Re: Workplan Addendum – Soil and Groundwater Investigation

Nady Systems 1137-1167 65th Street Oakland, California 94608 Case No. RO000082

Proposed Sampling Locations and Geophysical Notes and 'Gas Pump' Figure

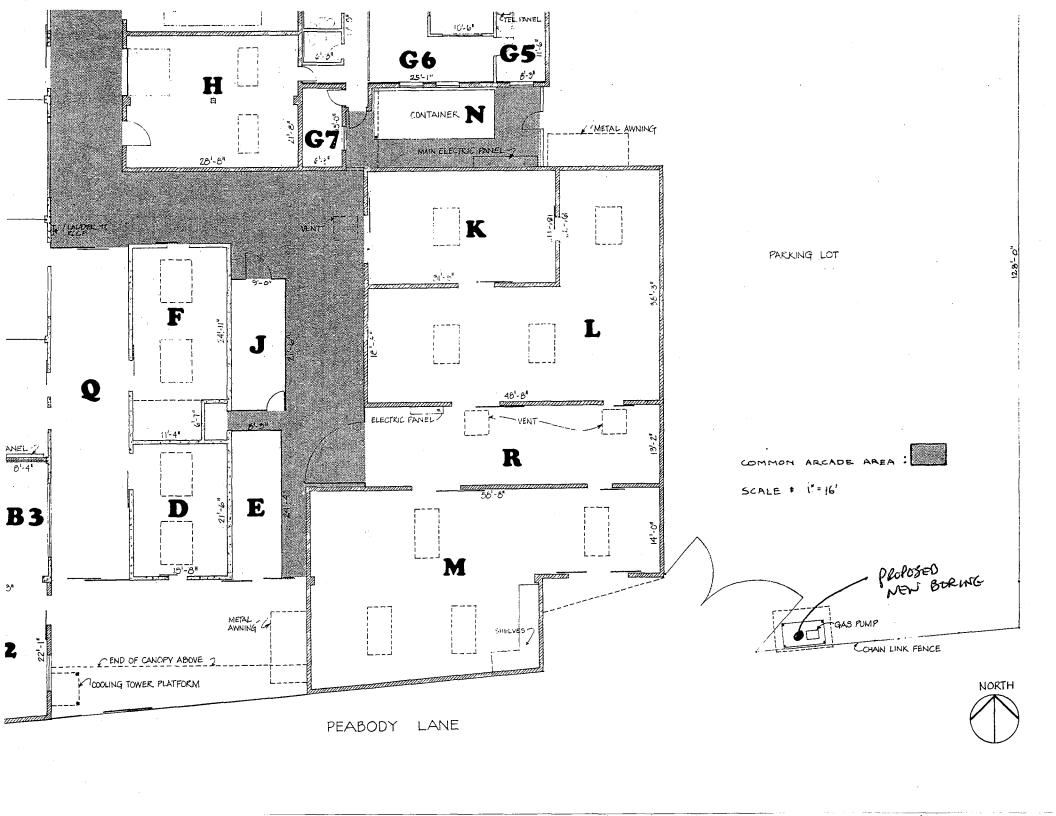
Your August 7, 2002 letter requested additional information regarding the 'gasoline tank' and 'gas pump' at the site. During our site walk to prepare for the upcoming investigation, Cambria observed disturbed asphalt in the location of the former 'gas pump' shown on the attached figure. The disturbed asphalt suggests that the 'gasoline' tank was located beneath the "gas pump." The tank was reported removed in 1982. As shown on the attached figures, Cambria proposes to complete one boring within the location of the former "gas pump."

Cambria Environmental Technology, Inc. As requested by your August 7, 2002 letter, Cambria conducted geophysical surveying to investigate the locations of piping at the site. Notes from the geophysical surveying are shown on the attached figure. As noted on the figure, Cambria was unable to locate piping emanating from the locations of USTs 1,2,3 & 4. We suspect two pipes emanate from USTs 5 & 6, head west and encounter another pipe at an angle (not perpendicular as previously estimated) within a very small room. North of this location the piping appears to head northwest toward 65th Street.

Based on this information Cambria proposes completing one boring approximately 10 ft west of UST 5. This boring would provide subsurface information downgradient of UST 5 and upgradient of the suspected piping junction in the small room west of UST 5. This proposed modification would eliminate one boring since the limited accessibility in the small room would place the requested two borings approximately 10 feet apart.

Cambria also proposes completing one boring immediately adjacent to the piping found in the hallway in the central portion of the site. This boring would replace the two borings that were requested along the suspected location of the piping in that area. The orientation of the piping in the hallway suggests the piping could come from the small room west of UST 5. Our geophysical subcontractor commented that the piping in the hallway in the central portion of the site could be a water line.
